ADDENDUM No. 1
Reconstruct GA Apron – Phase 1 Construction
March 12, 2024

Reconstruct GA Apron – Phase 1 Construction

FAA AIP No. 3-19-0028-078
Iowa DOT No. 91240DBQ100

SHEET NO.
U.03

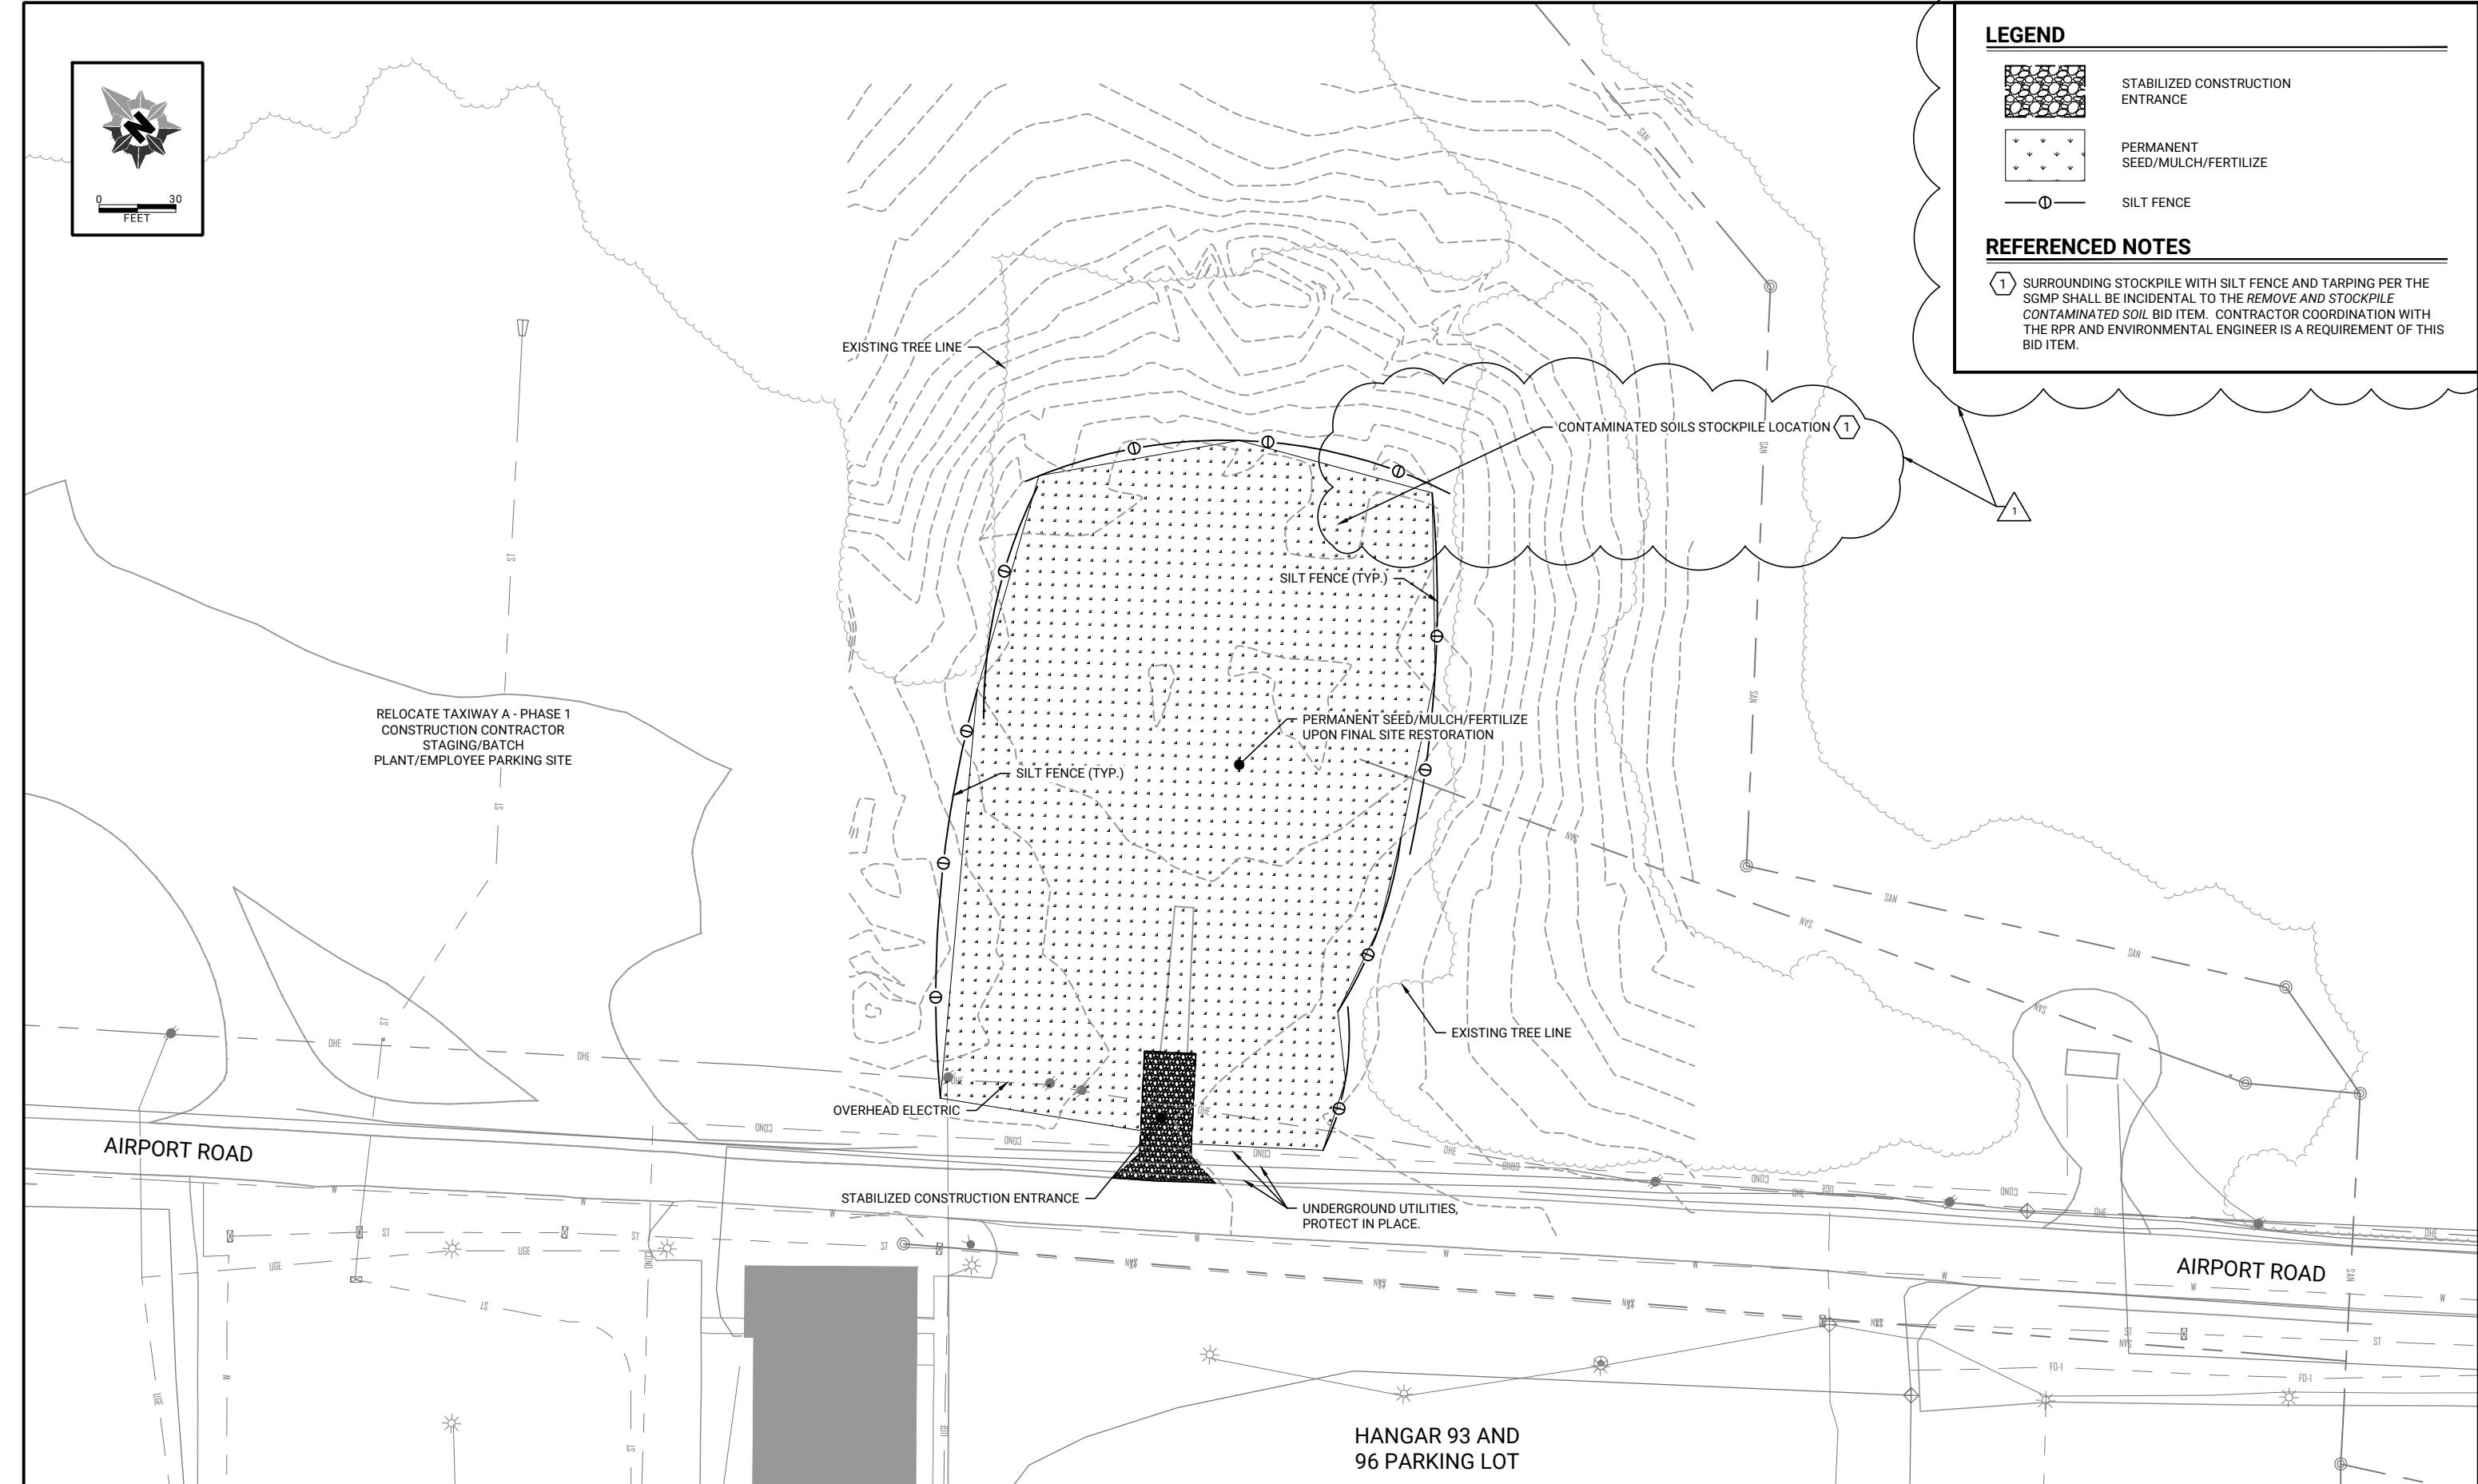
- **ADD** Note “Contaminated Soils Stockpile Location.
- **ADD** Referenced Note 1 “Surrounding Stockpile with Silt Fence and Tarping per the SGMP Shall be Incidental to the *Remove and Stockpile Contaminated Soil* Bid Item. Contractor Coordination with the RPR and Environmental Engineer is a Requirement of this Bid Item.”
